Access Compliance Report Public Rights-of-Way (Curb Ramps)

Main Street: BRIMHALL_DR		Cross Street: MONTECITO_RD		Location:	NW
ADA ID: RPRK211206151651	Ramp Type: Type 4 - Parallel	Initial Pass/Fail: Fail	Overall Compliance: No	Severity Score:	15
Codes/Mitigation Info/Possible Solution			Field Measurements/Component Compliance

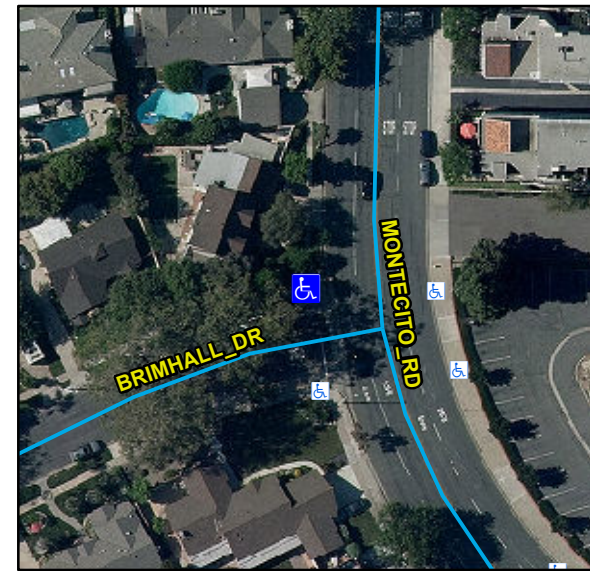
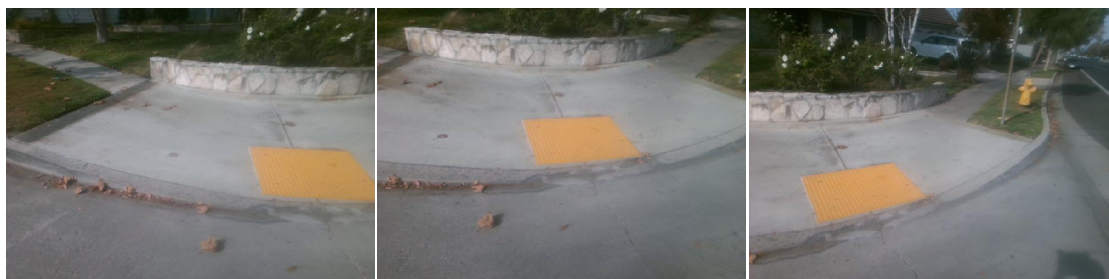
Compliance	Description	Data	Compliance	Description	Data
N/A	Ramp Length LT (in)	112	N/A	Ramp Length RT (in)	121
Yes	Ramp Width LT (in)	108	Yes	Ramp Width RT (in)	108
Yes	Ramp Run Slope LT (%)	8.2	Yes	Ramp Run Slope RT (%)	7.7
No	Ramp Cross Slope LT (%)	2.5	No	Ramp Cross Slope RT (%)	5.4
N/A	Landing Present	N/A	N/A	DWS Provided	N/A
N/A	Landing Length (in)	N/A	N/A	DWS Contrast	N/A
N/A	Landing Width (in)	N/A	N/A	DWS Length (in)	N/A
N/A	Landing Run Slope (%)	N/A	N/A	DWS Full Width	N/A
N/A	Landing Cross Slope (%)	N/A		DWS Offset Type	N/A
N/A	Landing Movement Obstructed?	N/A	N/A	DWS Offset Left (in)	N/A
	Landing Movement Type	N/A	N/A	DWS Offset Right (in)	N/A
N/A	Landing Shared	N/A			
N/A	Clear Space	Yes			
N/A	Clear Space To Crosswalk (in)	N/A			
N/A	Marked Crosswalk 1	No	N/A	Marked Crosswalk 2	No
	Crossing 1 Direction	S		Crossing 2 Direction	E
	Marked Crosswalk 1 Width (in)	N/A		Marked Crosswalk 2 Width (in)	N/A

Remove & Replace Curb Ramp With Two New Directional Ramps or Equivalent.

R304.5.3, STD 1115
